**ON-SITE SEWAGE DISPOSAL SYSTEM
 HOWARD COUNTY HEALTH DEPARTMENT
 BUREAU OF ENVIRONMENTAL HEALTH**

SUBDIVISION: Everlea III LOT NUMBER: 8, Block B

ADDRESS: 1515 Everlea Road PROPERTY OWNER: Steve Wolchinsky

SITE INSPECTION SHEET

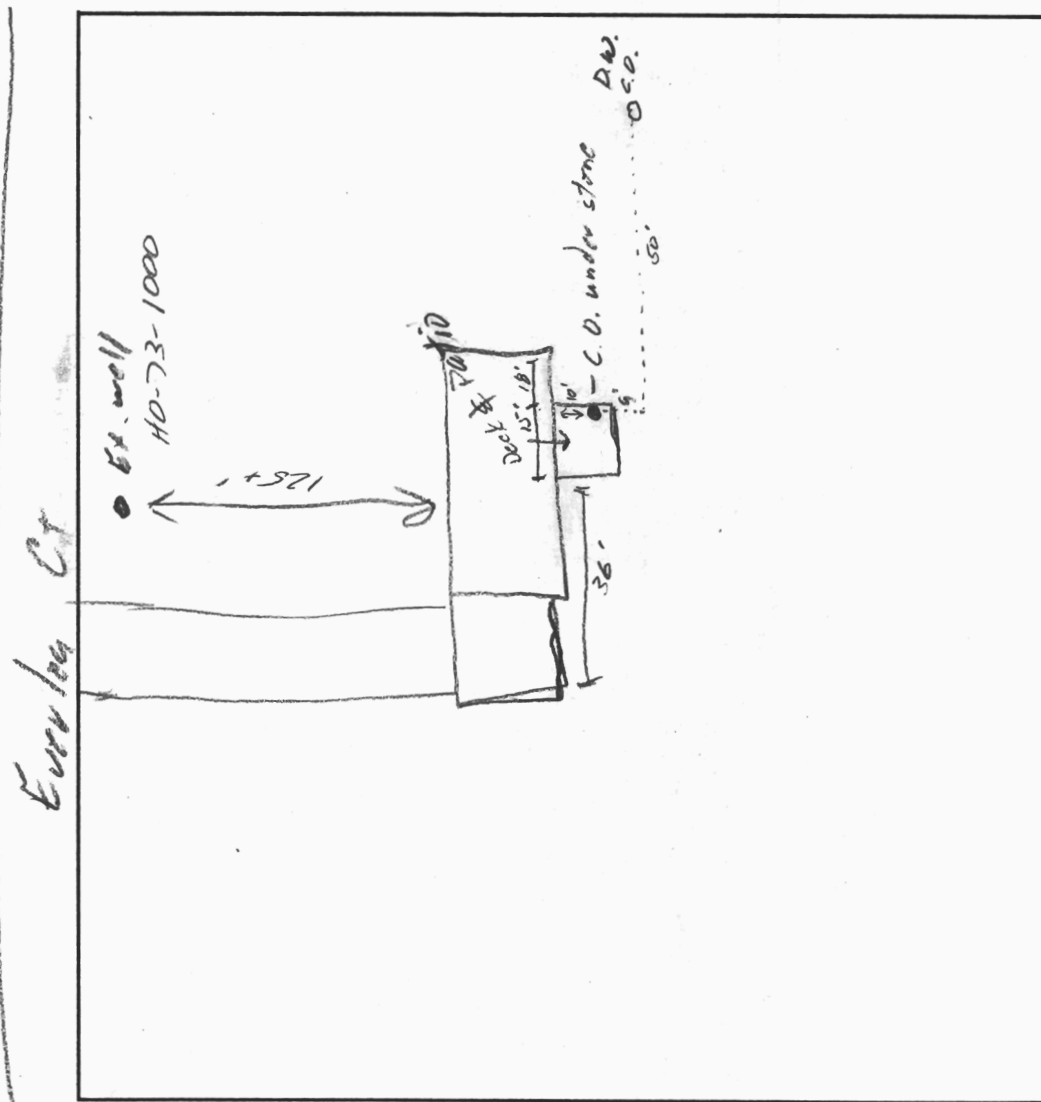
MARKS: 10/1/74 red cleanout right to grade, inlet
pipe needs to be enclosed into
Dry well
4/12/74 Cleanouts cemented. System otherwise OK.

SYSTEM APPROVED 4/12/74 INSPECTOR William H. Zorn

LOCATION DIAGRAM Needs abandoned

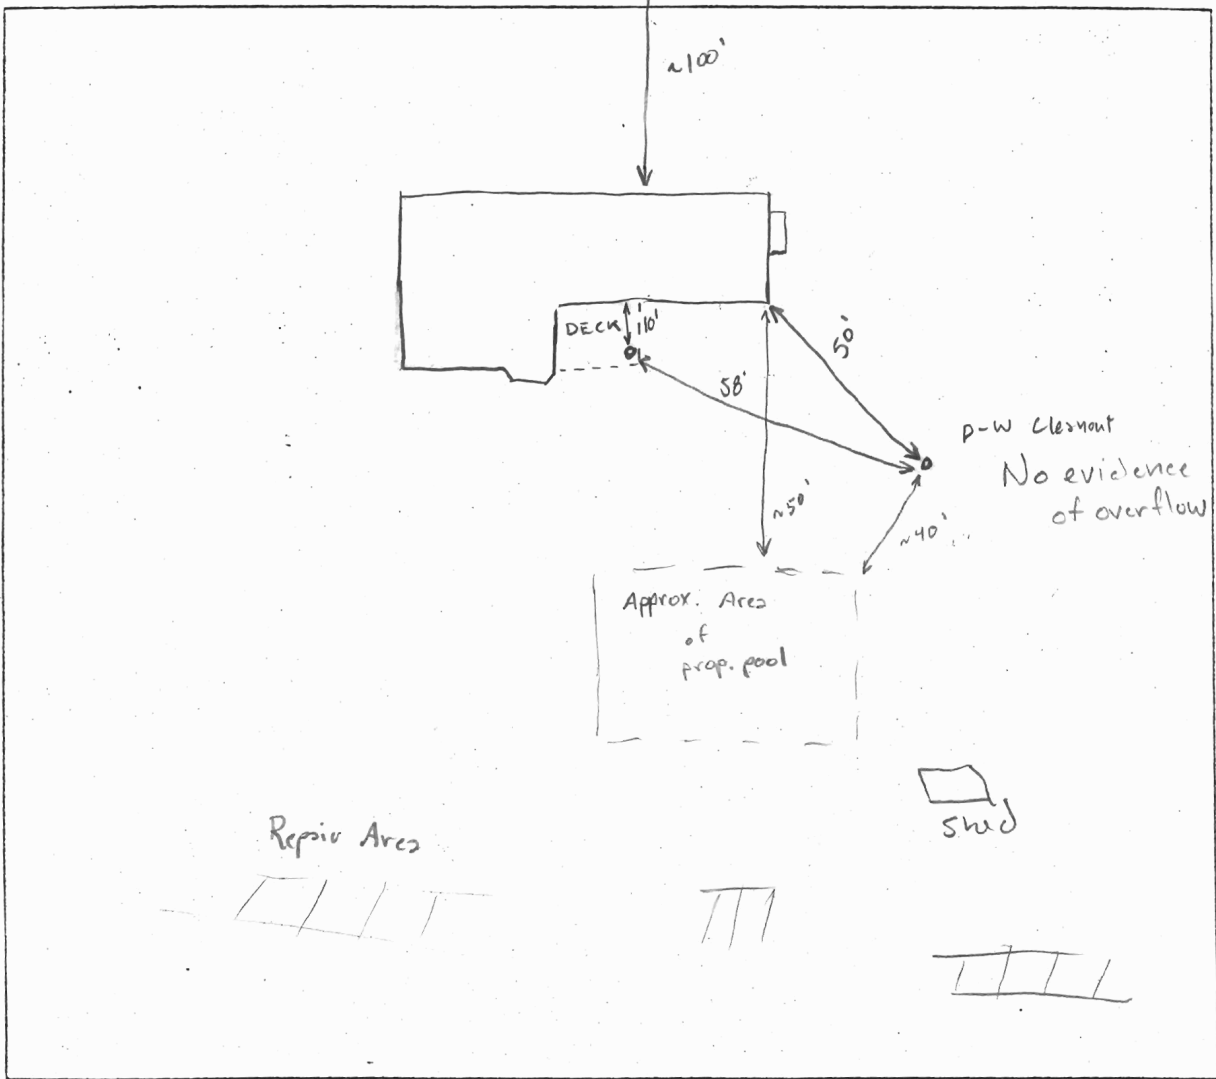
COMMENTS: Area of pool is most sensible area for septic repair. No indication that area further toward back of lot is not good repair area. though. Recommendation - Permit issuance
